CALL NO. 100
CONTRACT ID NO. 241306
ADDENDUM # 1

Subject: Breathitt County, NHPP 0151 (090)
Letting March 21, 2024

- (1) Added - Traffic Management Plan - Pages 583A-583L of 649
- (2) Revised - Plan Sheets U-039, U-041, U-042, U-044, U-045, U-047

Sheet No.	U-039
City of Jackson - Utility Relocation	BREATHITT COUNTY, KY - KY15, ITEM NO. 376.00
Date	2023-08-17
Drawn By	JCM
Scale	AS SHOWN
Job No.	933.40

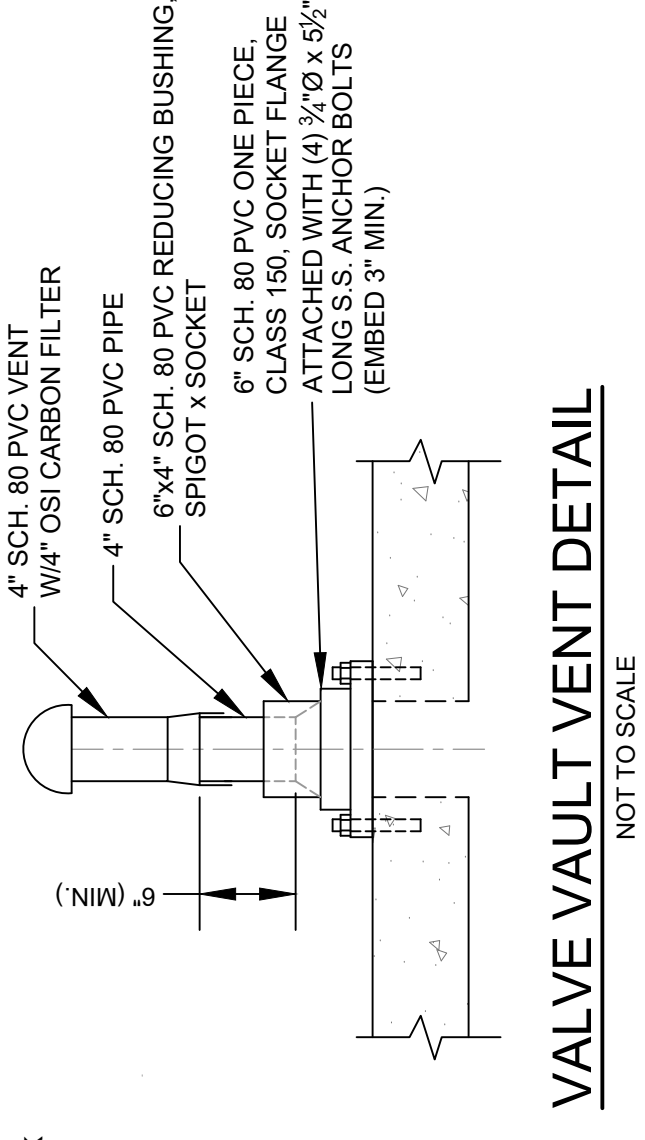
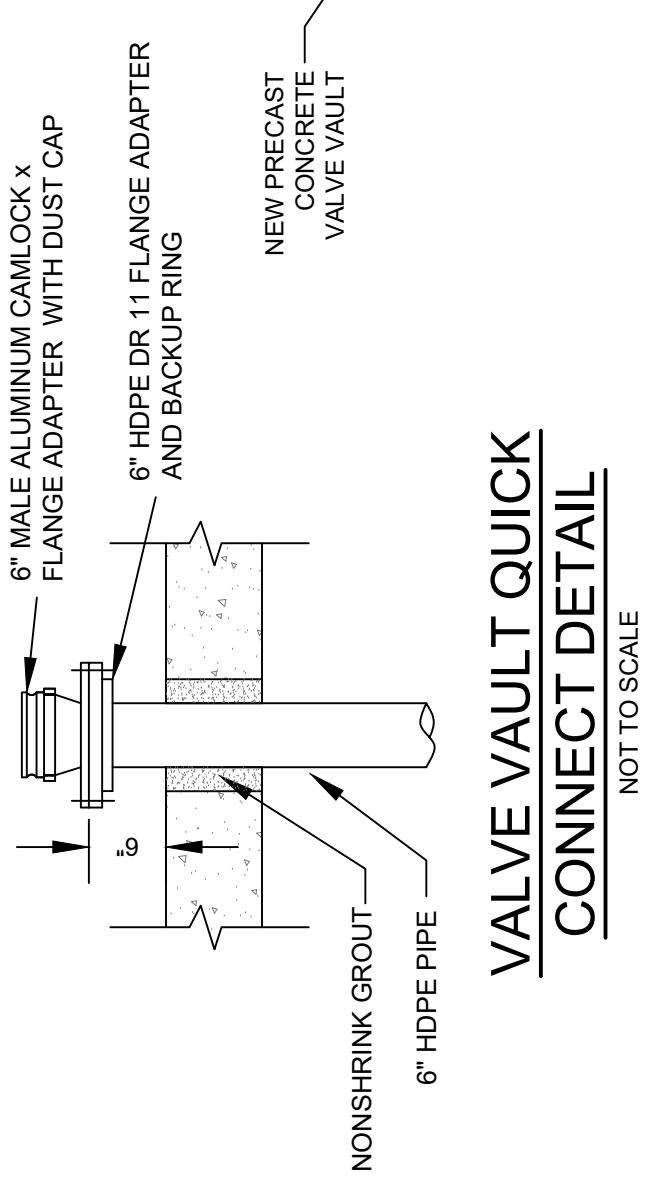
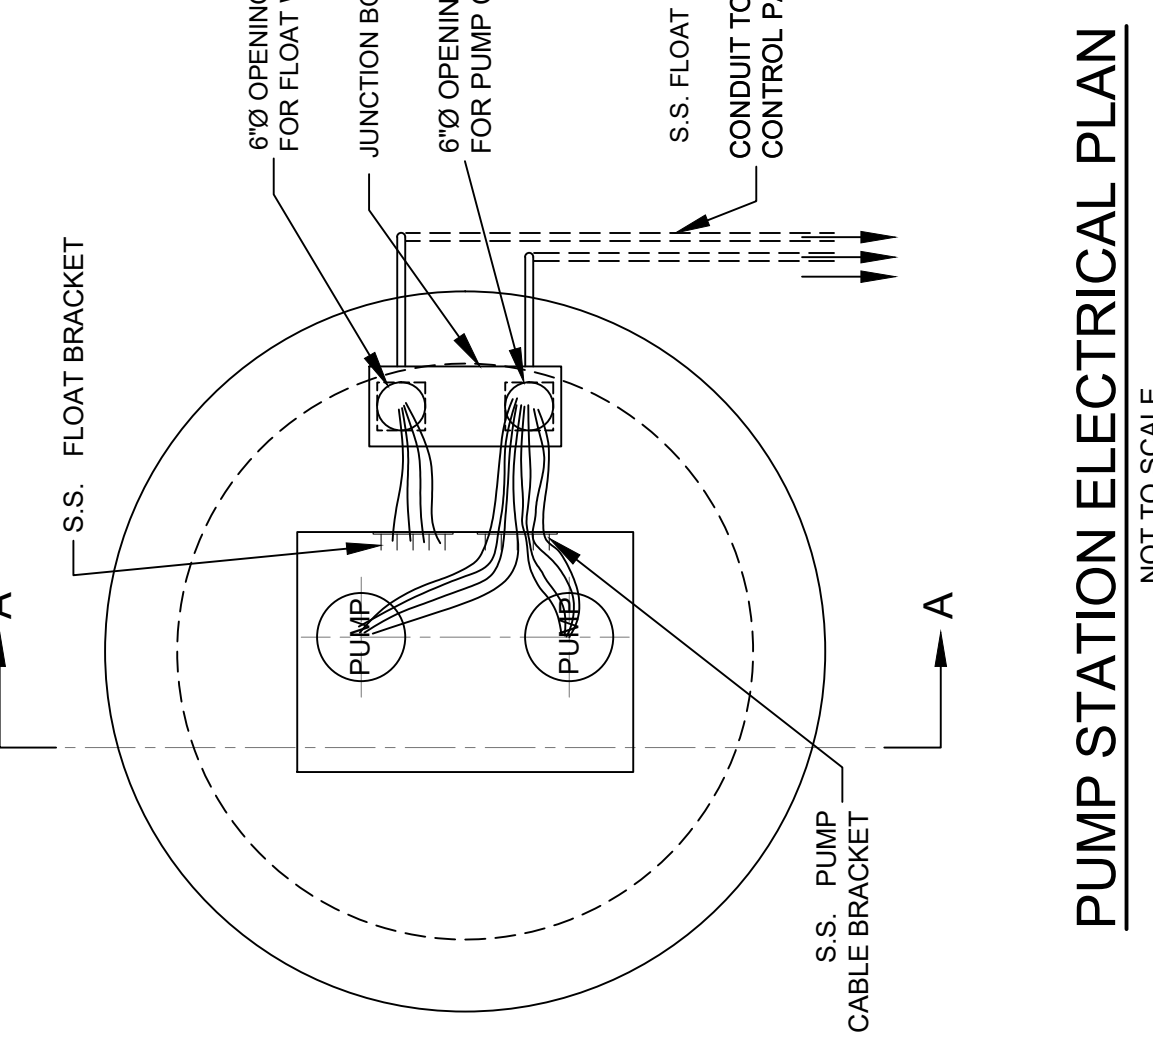
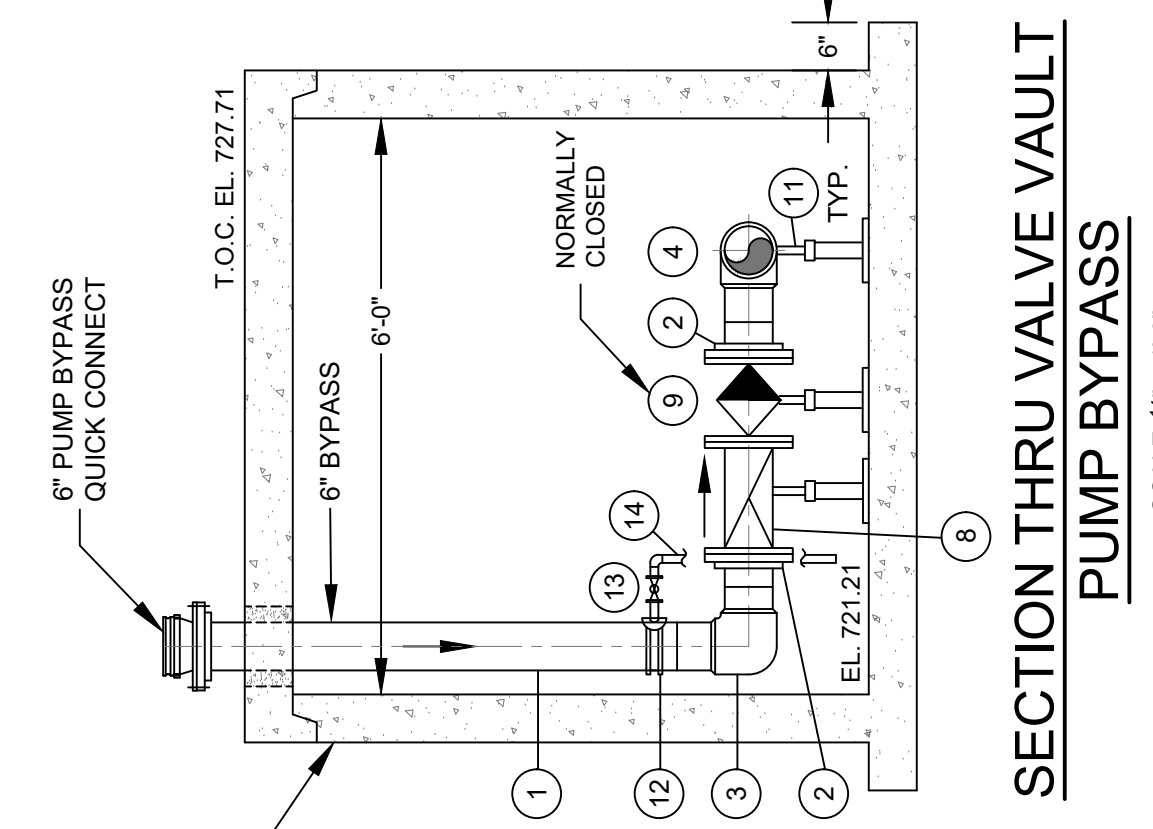
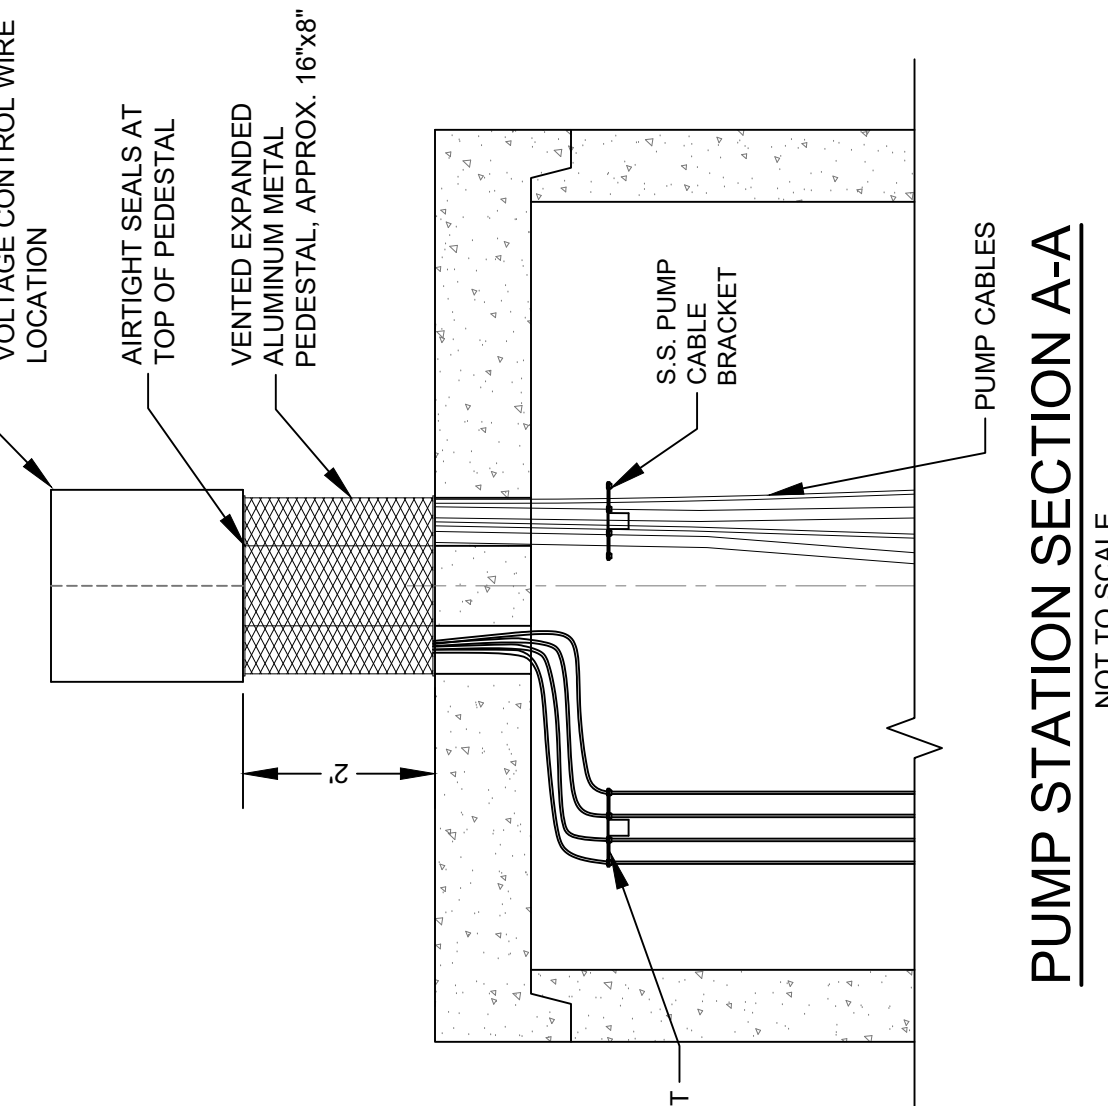
2024-02-20 ADD1, ADD GATE VALVE
